# Modele De Capital Ind Ltd (Unit 2) (Extension)

No 2 Hajiganj, Narayanganj, Bangladesh.

18 June 2026

### Observation-02: Validity and duration of building permit and applicable building code in the design report. [Knitting Shed]

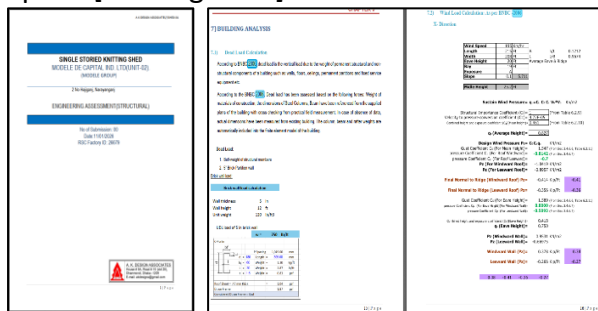
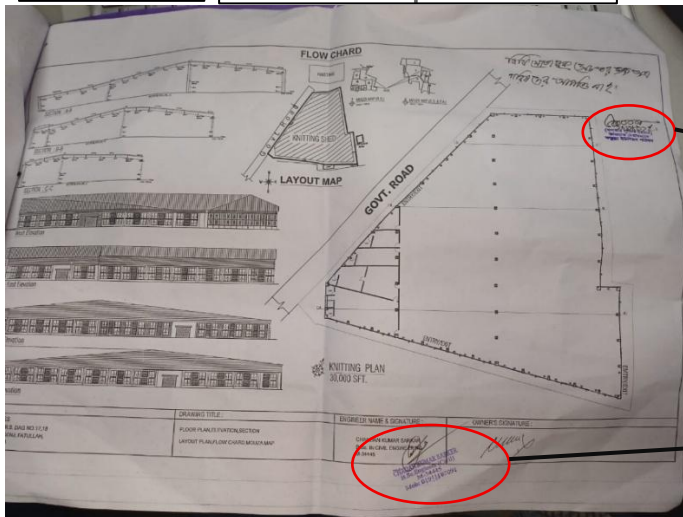
**Description:** The construction was started after 2024 for Knitting Shed. However, the building permit was taken on August-2011. So, the structure was constructed after the validity period of the building permit. Also, design report has been prepared following BNBC 2006.

The factory is required to obtain fresh permit from the local authority, the structures shall be subjected to reassessment based on the obtained Building permit in accordance with the applicable provisions of the Code. Submit the revised design report to RSC for detailed review.

### Observation-03: Inconsistency in the geotechnical investigation report. [Knitting Shed]

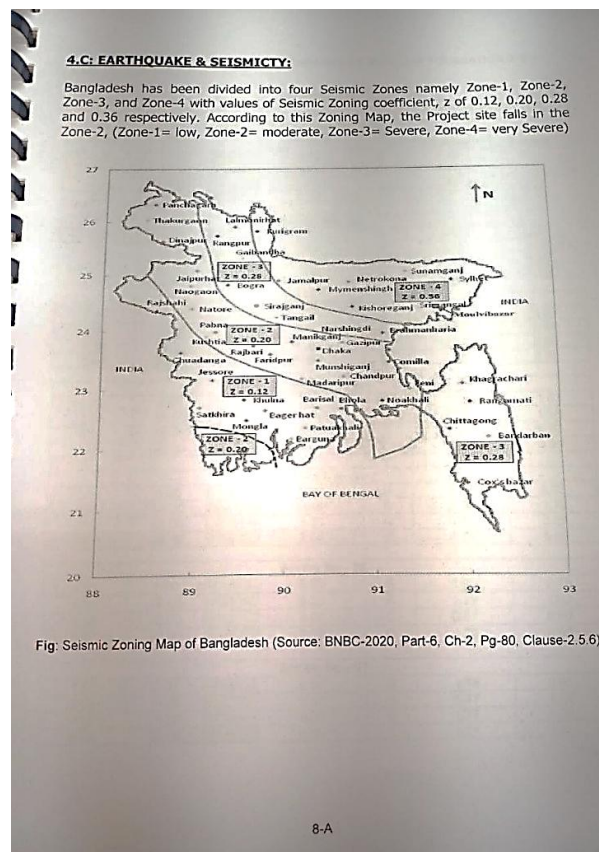
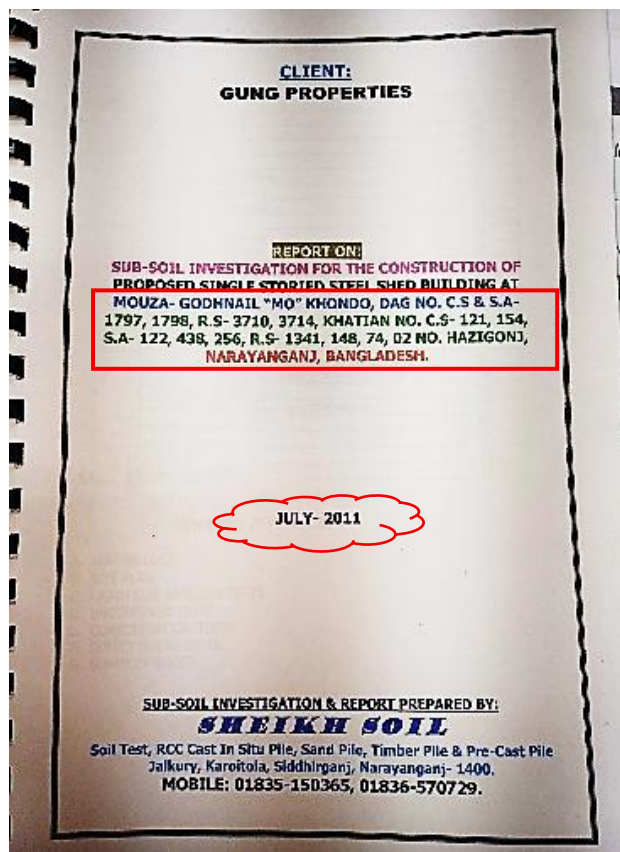
Mouza and Dag no's do not match with the project location

Report preparation date mentioned 2011 but seismic zoning map shown as per BNBC 2020

**Description:** Inconsistencies were identified in the geotechnical investigation report. The reported locations do not match the project location, making it difficult to verify the actual investigation site. Additionally, the report preparation date was stated as 2011; however, the seismic zoning map presented is based on BNBC 2020, raising concerns regarding the authenticity and reliability of the report.

The building engineer is required to carry out a new geotechnical investigation, incorporate the investigation results and recommendations into the design report, and submit both the geotechnical investigation report and revised design report to RSC for detailed review.

### Observation-04: Loose and inactive cable bracing. [Knitting Shed]

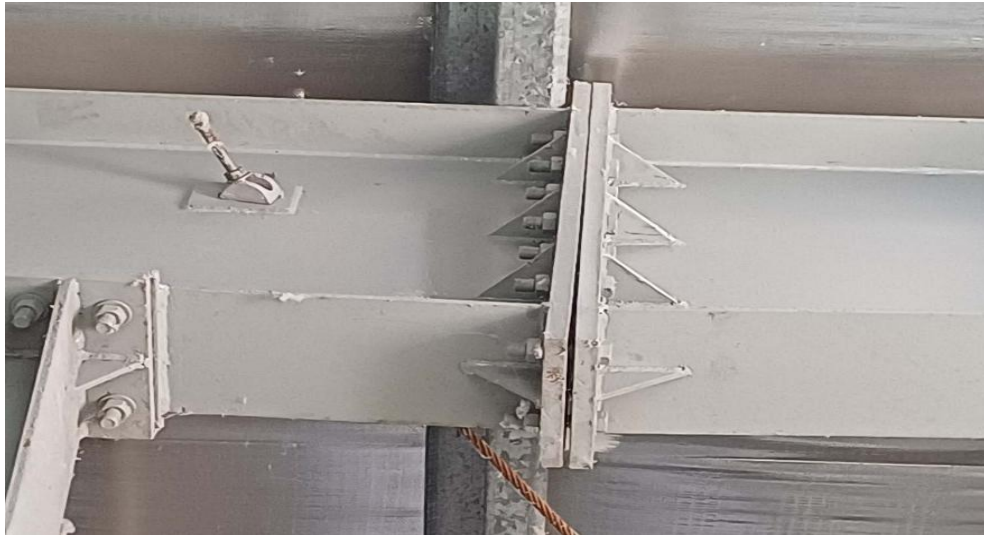
**Description:** During the inspection, some cable bracings were found loose. The factory is required to tighten all loose bracings.
